Citywide Privacy Walls for Eight Sites
City of Lauderhill, Florida
RFP NUMBER: 2019-008

GO BOND CITYWIDE WALLS DESIGN AT EIGHT SITES City of Lauderhill, Florida BID NUMBER: 2019-008

ADDENDUM NUMBER 3

ADDENDUM NUMBER 4

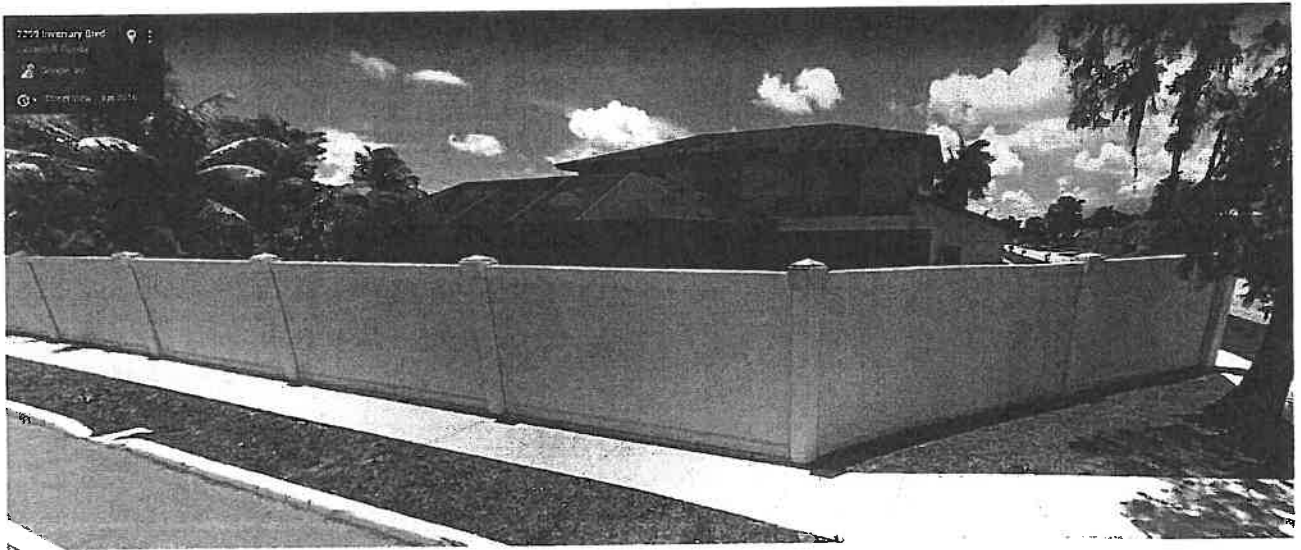
Question 2: Is it the City's intention to have multiple wall styles and specifications at the various locations, or will the City identify a standard basis of design and approved manufactures for all the installations? Non-specific basis of design may lead to bidders basing

their pricing on product that ultimately may not be approved and create an uneven bidding scenario.

Answer 2: The city's intention is to install wall systems that are similar in appearance (20' wide panels) and installation method to existing wall systems throughout the city. Approved equals will be accepted. Example below located at the intersection of NW 73rd Avenue & Inverrary Boulevard.
